UN Regulation No. 95 (Lateral collision)**Proposal for to the 05 series of amendments of Regulation
No. 95 (Lateral collision)****Submitted by the experts from Japan and the European Commission on
behalf of Task Force ***

The text reproduced below has been prepared by the experts from Japan and the European Commission on behalf of the Task Force to amend the requirements concerning post-crash electrical safety in the event of lateral collision. It is based on GRSP-66-33 distributed at the sixty-six session of the Working Party on Passive Safety (GRSP) (see ECE/TRANS/WP.29/GRSP/66, para. 35). The modifications to the current text of the Regulation are marked in bold for new or strikethrough for deleted characters.

Figure 3
Jointed Test Finger

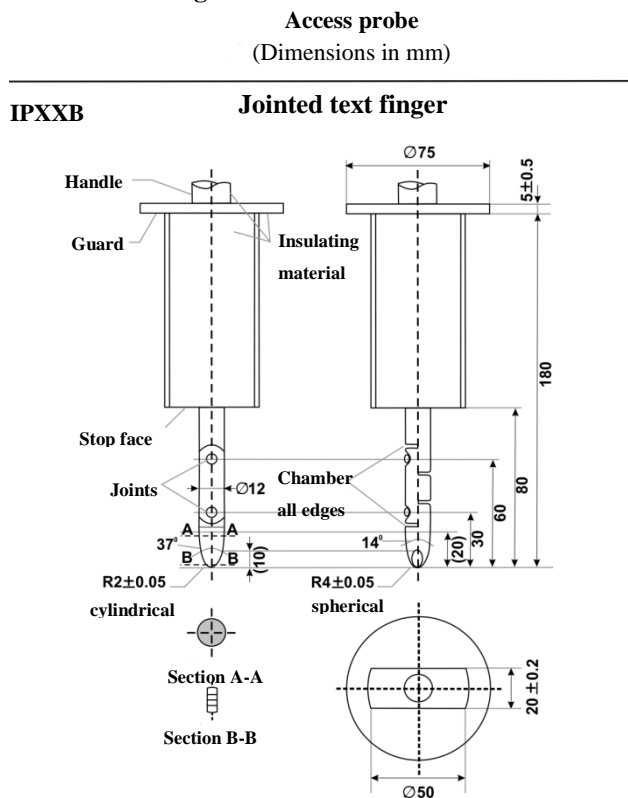
The jointed test finger described in **Figure 3** of ~~Appendix 1~~ shall be inserted into any gaps or openings of the physical protection with a test force of $10\text{ N} \pm 10$ per cent for electrical safety assessment. If partial or full penetration into the physical protection by the jointed test finger occurs, the jointed test finger shall be placed in every position as specified below.

The requirements of paragraph 5.3.7.1.3. of this Regulation ~~are shall be considered to be~~ met if the jointed test finger described in Figure 31 of Appendix 1, is unable to contact high voltage live parts.

Figure 4

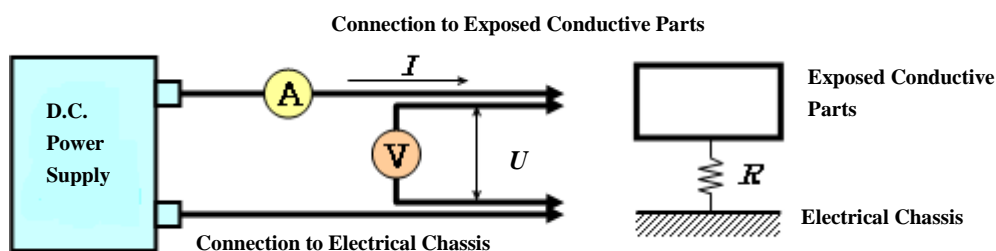
(b) Test method using DC power supply, voltmeter and ammeter.

The DC power supply, voltmeter and ammeter are connected to the measuring points (Typically, electrical chassis and electro conductive enclosure/electrical protection barrier).

The voltage of the DC power supply is adjusted so that the current flow becomes at least 0.2 A.

The current "I" and the voltage "U" are measured.

The resistance "R" is calculated according to the following formula:

Example of the test method using DC power supply, voltmeter and ammeter is shown below.

Figure 5
Measurement of U_1'

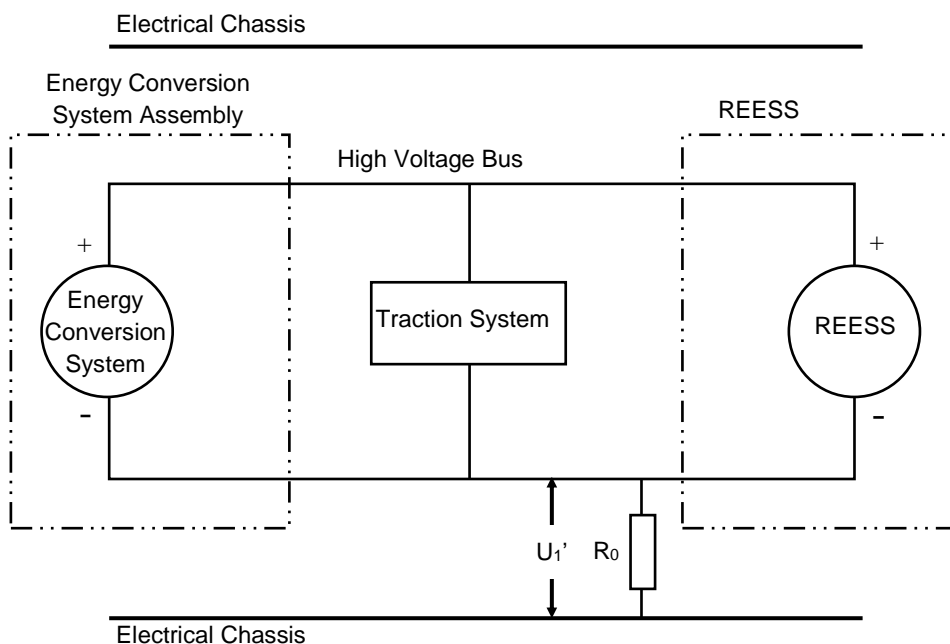
If U_1 is greater than or equal to U_2 , a standard known resistance (R_0) is inserted between the negative side of the high voltage bus and the electrical chassis. With R_0 installed, the voltage (U_1') between the negative side of the high voltage bus and the electrical chassis is measured (see Figure 5).

The electrical isolation (R_i) is calculated according to the following formula:

Figure 6
Measurement of U_2'

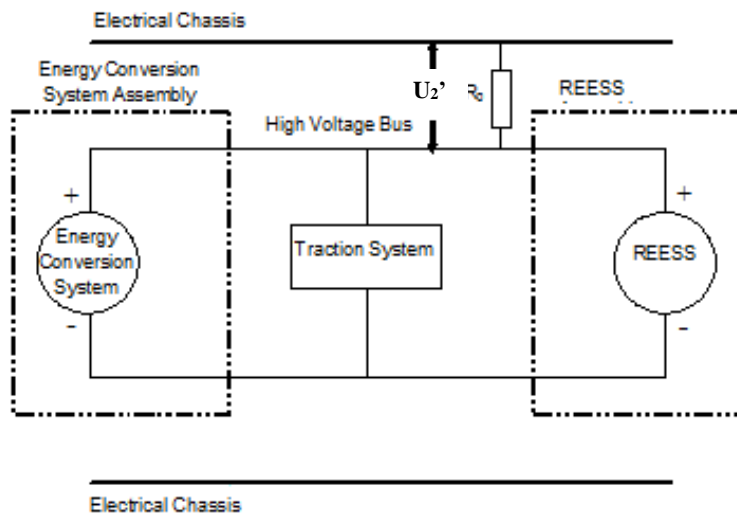
If U_2 is greater than U_1 , insert a standard known resistance (R_o) between the positive side of the high voltage bus and the electrical chassis. With R_o installed, measure the voltage (U_2') between the positive side of the high voltage bus and the electrical chassis (see Figure 6 below). The electrical isolation (R_i) is calculated according to the following formula:

$$R_i = R_o * U_b * (1/U_2' - 1/U_2)$$
